August 6, 2014

Re: Allston - The I-90 Massachusetts Turnpike Interchange Project, Evaluation Criteria

POSSIBLE STREET PATTERN
NORTH ALLSTON
ALTERNATIVE A

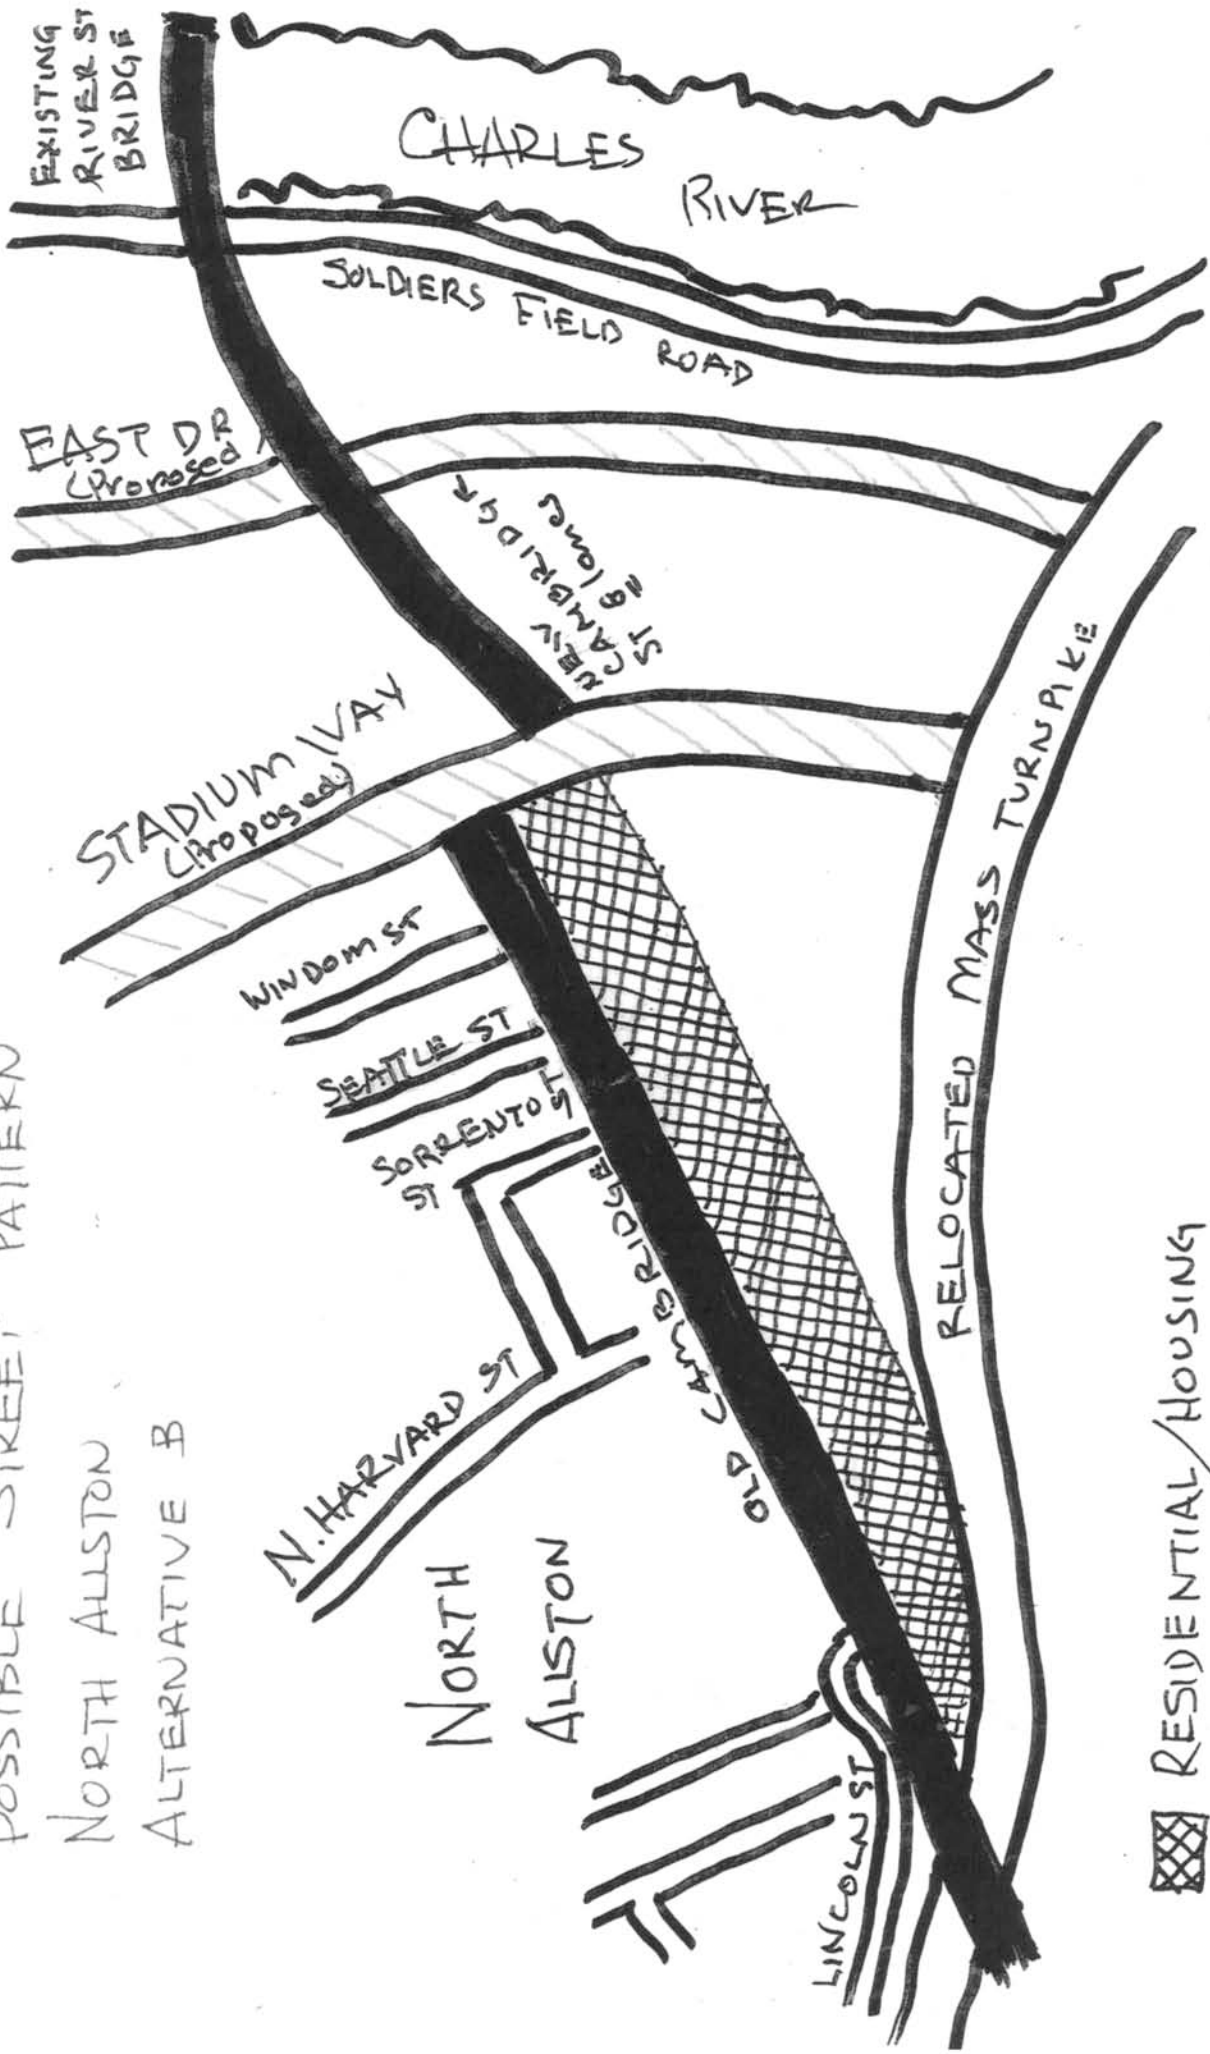
2. Cambridge Street Bypass – Separate local and regional traffic operations should be evaluated. Multiple lanes of traffic (6 to 8 minimum) will likely be necessary for Cambridge Street to accommodate traffic movements. The number of lanes should be defined as soon as possible so that the neighborhood can comment on whether MassDOT should explore a two-street option that provides for a residential district on both sides of a narrowed Cambridge Street, plus a New Cambridge Street to provide connections to the Turnpike ramps, Stadium Way/East Drive and the River Street Bridge. (See attached diagrams of several conceptual possibilities.)
